**Hearing for Upper Hutt City Council Plan Changes PC49 “Open Space” and PC49 Variation 1 “Silverstream Spur”.**

**Save Our Hills (Upper Hutt) Incorporated**

Submitter S14 (PC49), S91 (PC49 V1) and Further Submitter FS14 (PC49), FS10 (PC49 V1)

Wednesday 29 November 2023

Figure 8 Guilford Land

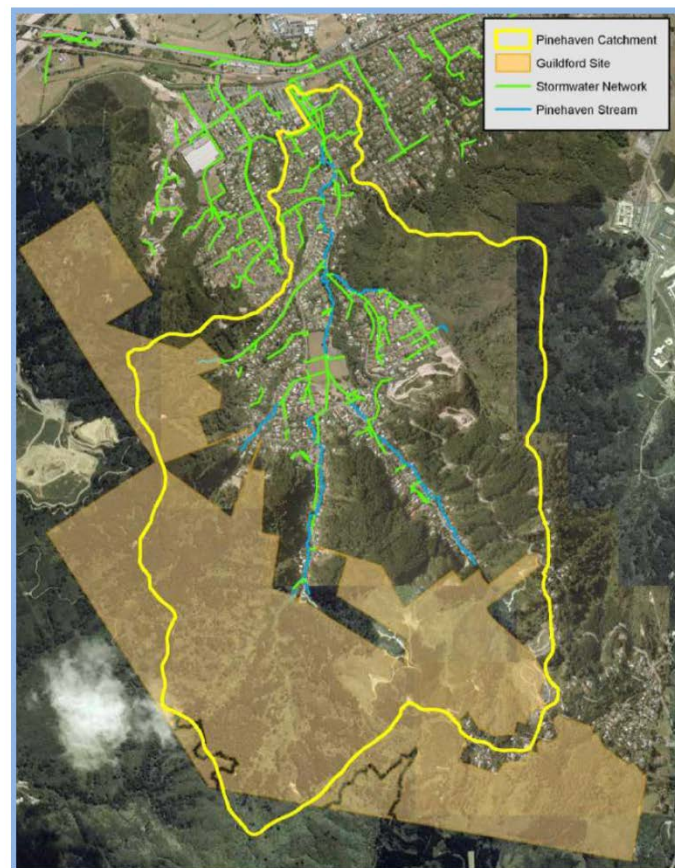
- 4.19 Regarding the hydrological modelling, the auditor questioned MWH as to why there was not the expected increase in unmitigated stormwater runoff from the 40% impervious areas introduced in the GTC development on the hills. MWH found the pre- and post- development hydrology models (the pre-development model being the baseline model of the existing situation for Pinehaven, and the post-development model being the model with the 1,665 new houses in it on the GTC land on the hills).

- 4.20 MWH’s response to the question of why the post-development model didn’t have any significant increase in stormwater runoff volume was because both models had the same ‘rainfall loss’ inputs, i.e. both the pre- development heavily vegetated (baseline) model and the post-development model (40% impervious surfaces of 1,665 dwellings and infrastructure) had the same rainfall losses.

Figure 8.1 – Existing and maximum probable development hydrographs

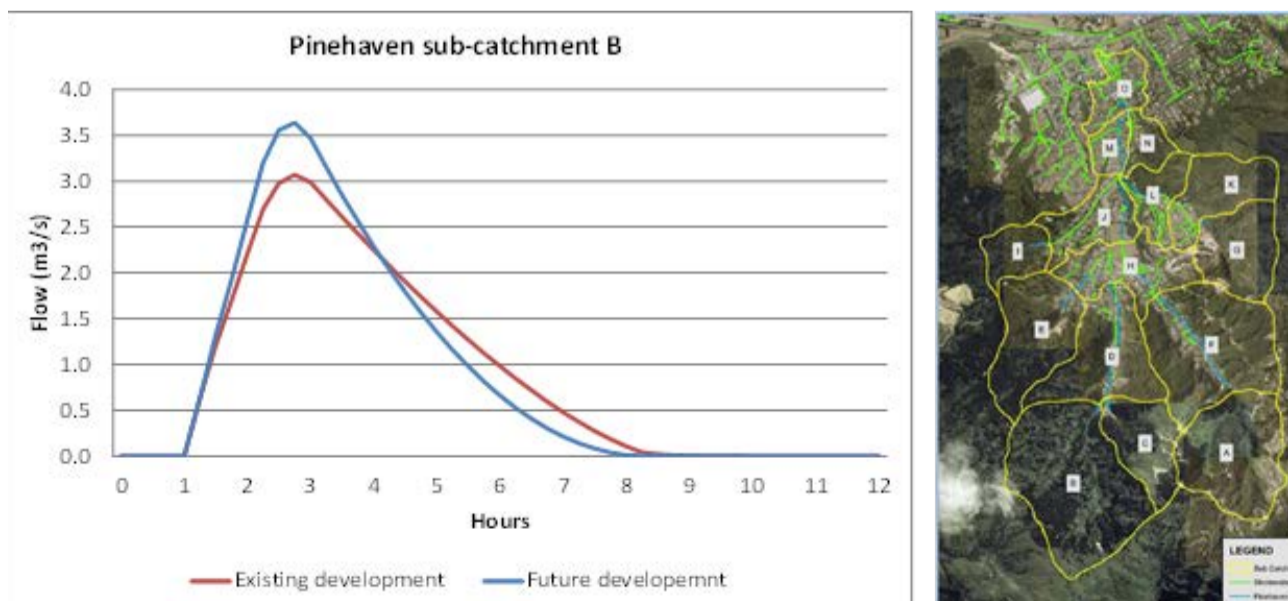
Thnaks for getting back to me. If the initial and continuing losses are the same in both models, then the flood volumes will be the same (so long as there isn't another % impermeable area parameter that negates the losses). So that could explain the volumes. Other parameters within the model could possibly speed up the runoff response to reflect that aspect of development.

Future development increases the peak flow by 18% (from 307m<sup>3</sup>/s to 3.64m<sup>3</sup>/s), and the flow recession is steeper than for the existing land use. However, the flood volume does not increase. This

Fig. 3a - Scheme Review No.4 - Map 2 - half the Spur changed to “Residential Conservation”

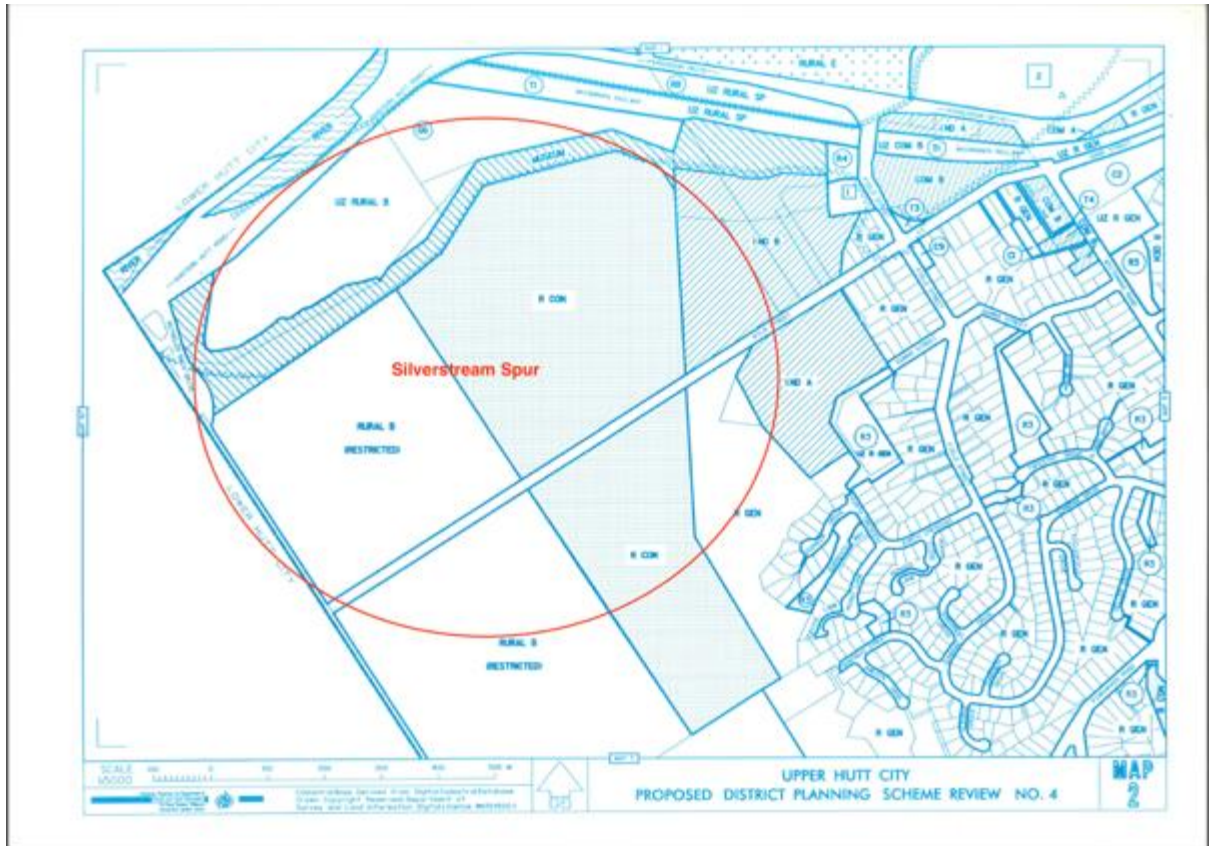
- 2.15 Although the District Scheme (Review No. 4) Map 2 publicly notified on 24 September 1991 showed over half the Spur zoned as 'Residential Conservation', there was nothing in the 'Scheme Statement' or 'Statement of Purposes, Objectives and Policies', or 'Code of Ordinances' in the Proposed District Scheme (Review No.4) mentioning anything about any proposal to change the zoning on the Spur from Green Belt to Residential Conservation.

Therefore, SOH regards the erroneous Residential Conservation zoning appearing on the Spur today as ‘General Residential’ with a ‘Residential Conservation Precinct’ overlay on Council’s Urban Planning Maps 39 and 40 as invalid, and requests that the Hearing Panel places no weight on claims by GTC that “*the operative zoning is more appropriate and fit for purpose*” than the proposed Natural Open Space zoning, and no weight on any attempt by GTC to use the erroneous Residential zoning as justification for a transport corridor through the Spur.

Fig. 11 - UHCC PC49 Planning Map – Silverstream Spur omitted from Open Space zones

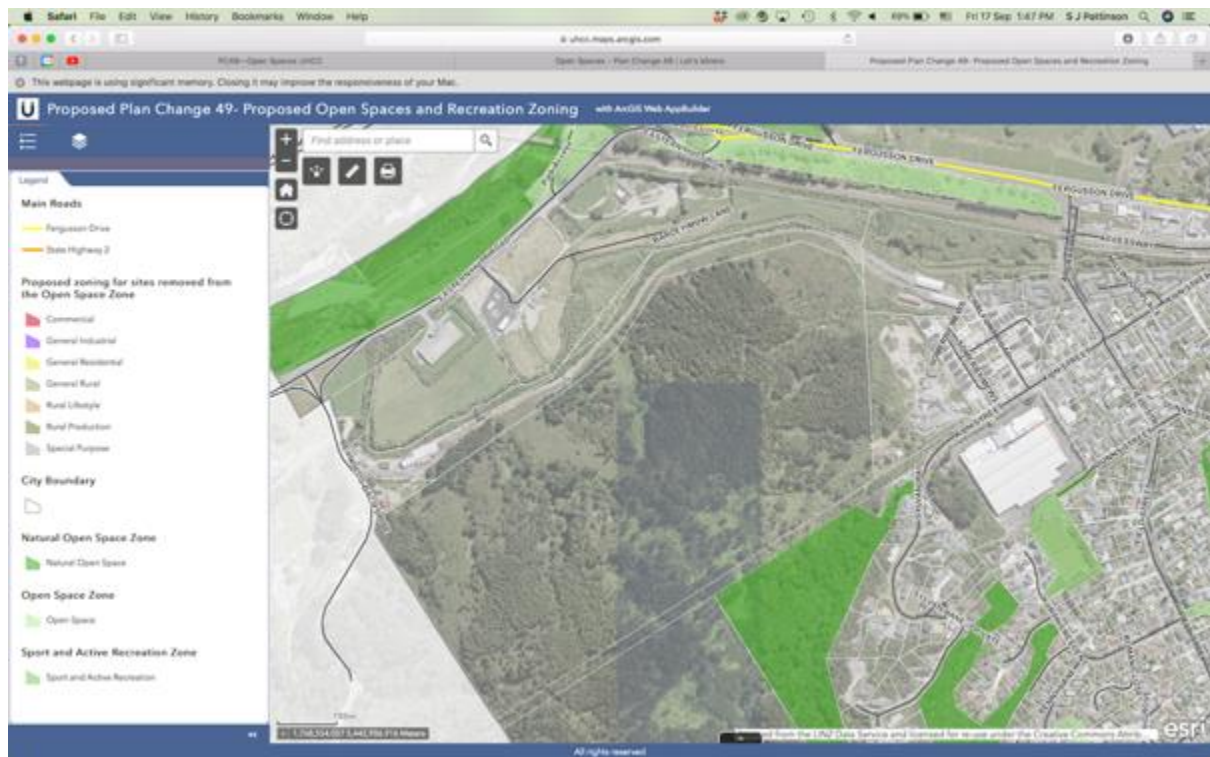
It is appropriate and indeed incumbent on Council to make good its promise back in 1992 to correct the error on its Urban Planning Maps 39 and 40 by including the Silverstream Spur in Plan Change 49 ‘Open Spaces’ and officially designating the Silverstream Spur under the Reserves Act 1977 as a “Scenic Reserve”. But regrettably Council left the Silverstream Spur out of Plan Change 49 (Fig. 11). The Spur has now been included in PC49 Variation 1.

Fig. 13 – Proposed change of zoning of Silverstream Spur to Natural Open Space in UHCC’s PC49 Variation 1 – Silverstream Spur.

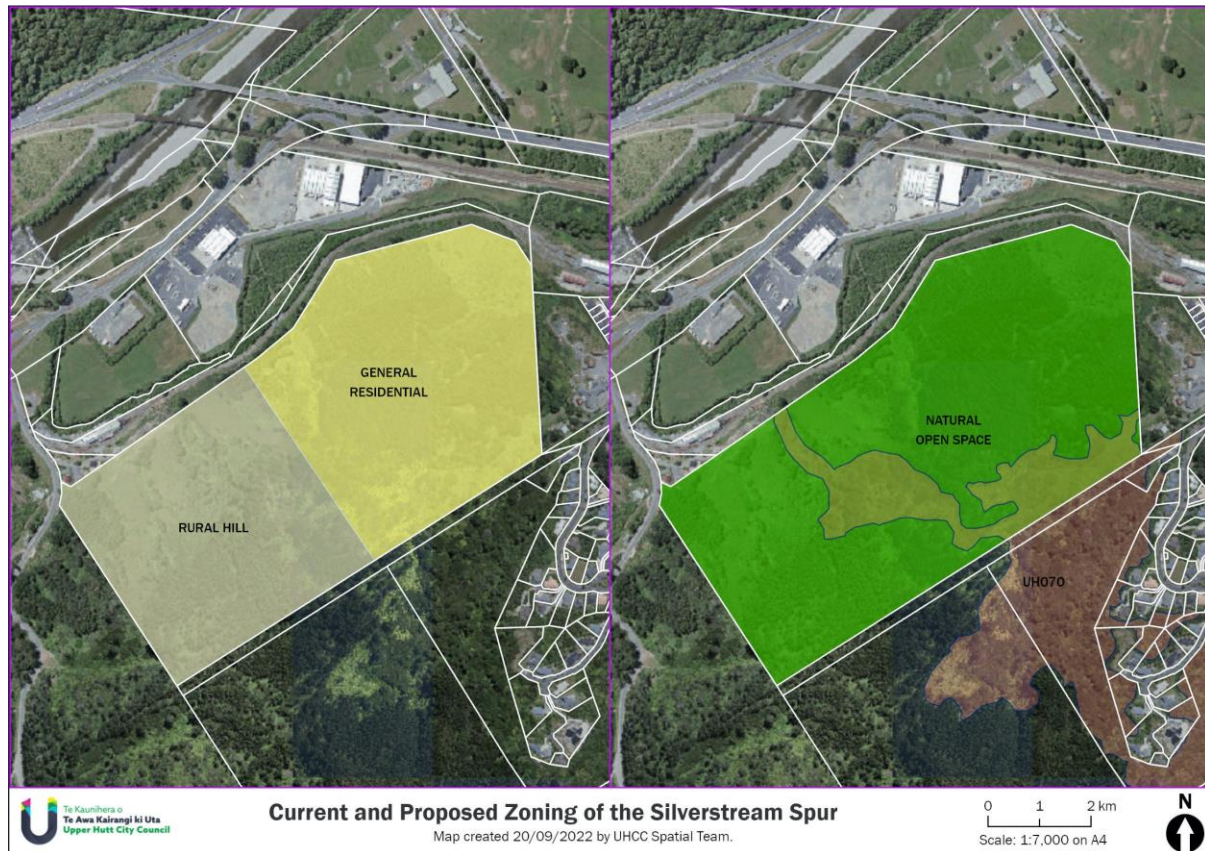
- 1.2 SOH applauds the s42A report’s recommendation to zone the Spur as a Natural Open Space Zone (NOSZ) in response to the many submissions requesting this. Given that SOH considers the current Residential zoning on the Spur to be invalid (I’ll explain the reasons why soon), re-zoning the Spur now as NOSZ is a good way of fixing the invalid zoning.

Although Council left the Silverstream Spur out of Plan Change 49, the Spur has now been included in PC49 Variation 1 (Fig. 13).
